REPORT TO THE AREA PLANNING COMMITTEE

Date of Meeting	18 th September 2024
Application Number	PL/2022/06908 (Full Planning Permission)
Site Address	Phase 6, Land at Hunters Moon, Chippenham
Proposal	Full Planning Application for 56 dwellings, associated parking, public open space, landscaping access, drainage works and associated infrastructure
Applicant	Bloor Homes South West
Town/Parish Council	Chippenham Town Council
Electoral Division	Chippenham Cepen Park & Hunters Moon
Grid Ref	390054, 171710
Type of application	Full planning application
Case Officer	Olivia Tresise

Document: B06367-CLK-XX-XX-BN-C-0002-P02 (Hunters 6 Flood Impact)
– Issued 25th June 2024:

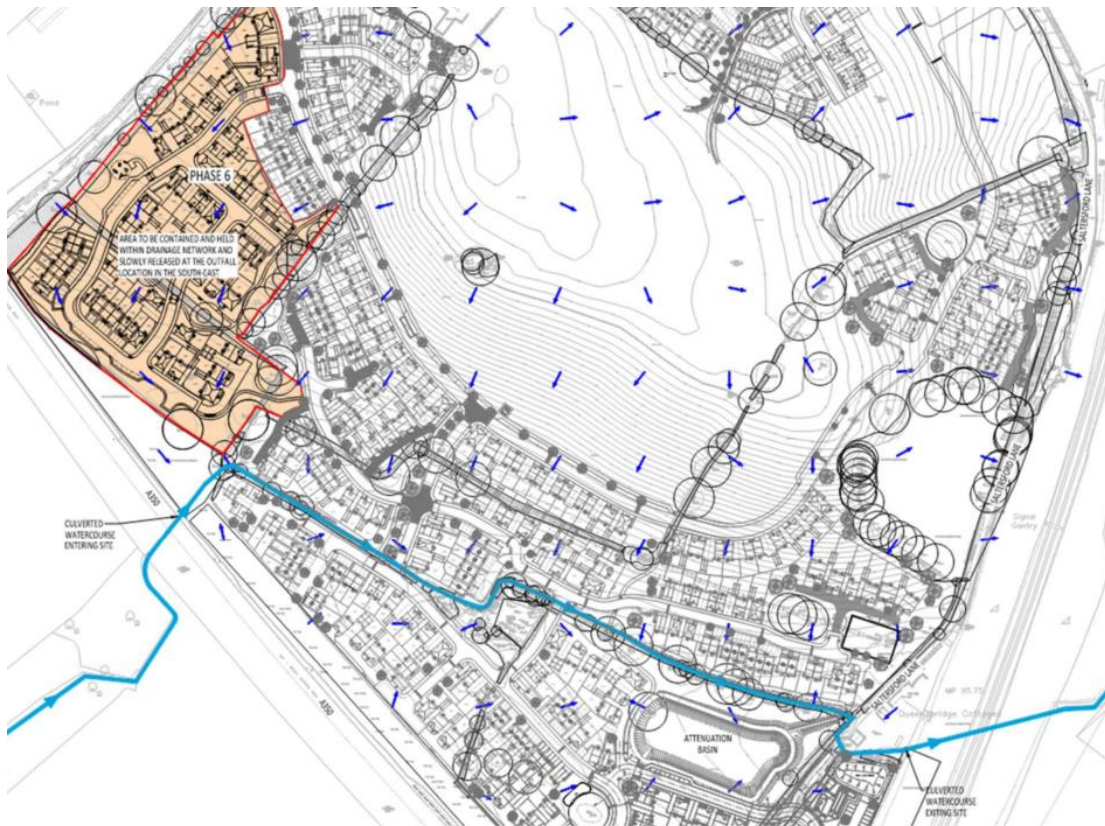
Image above from Page 1 demonstrates routing of watercourse, notes 2 areas of culverting:

- at the entrance below A350
- at the site exit via the Network Rail culvert below the railway.

Document: Drainage Layout Sheet 2 from 18/12062/REM:

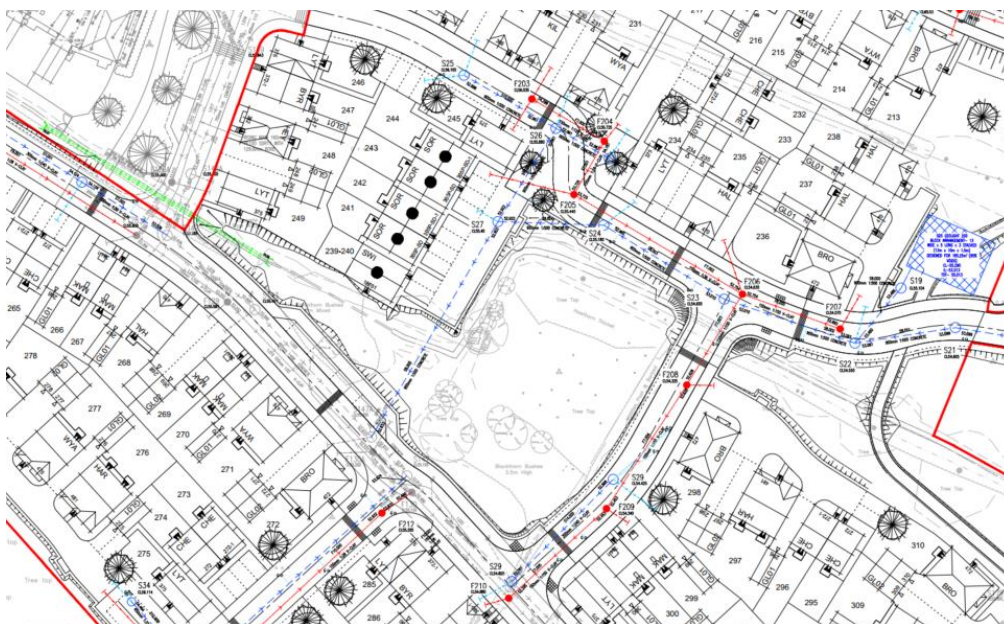
Image above from Phase 3 Drainage Layout displays onsite watercourse routing, notably between Arable Close and Ferguson Road. It is unclear from publicly available site plans where the watercourse has been culverted, and where the watercourse is unculverted.

The Drainage Engineer noted in Section 4.9.3 Ordinary Watercourse Flooding, Page 22 of the Flood Risk Assessment (16/12493/FUL) the applicant stated in the 2016 FRA “an easement of 5m from the ordinary watercourse is proposed whereby no building is permitted”.

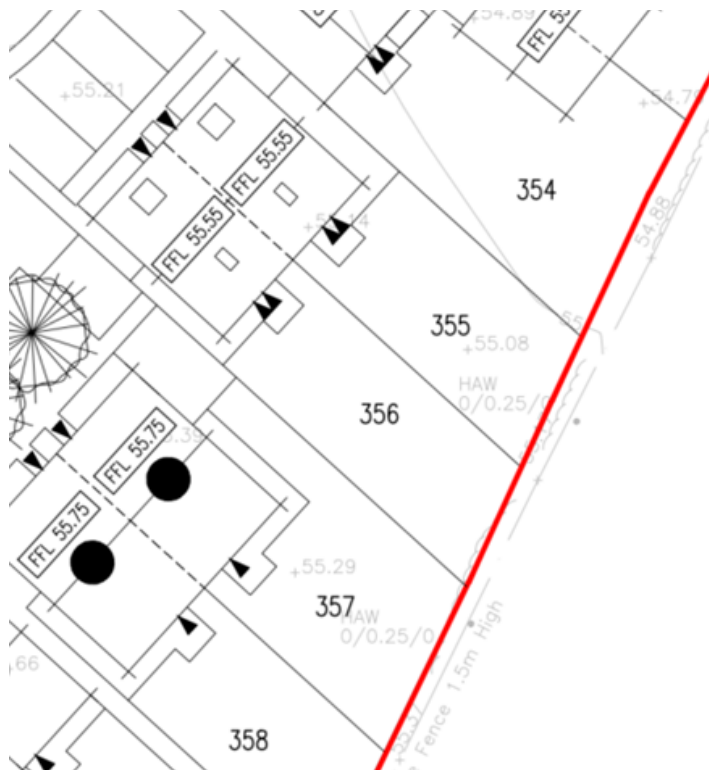
The Drainage Engineer noted node S417 has a hydrobrake that connects in the existing Network Rail culvert, with a design flow of 2.4l/s.

Action B: The applicant must confirm flow is restricted to 2.4l/s, and that this rate is no greater than the pre-development greenfield rate, or a previously agreed discharge rate.

Reason: to confirm the discharge rate is in adherence with agreed rate.

Recommendations: This requires little new evidence from the applicant, mainly confirmation of adherence to plans. The LLFA would recommend the applicant gathers all information relevant as requested and provides to residents & the LLFA.
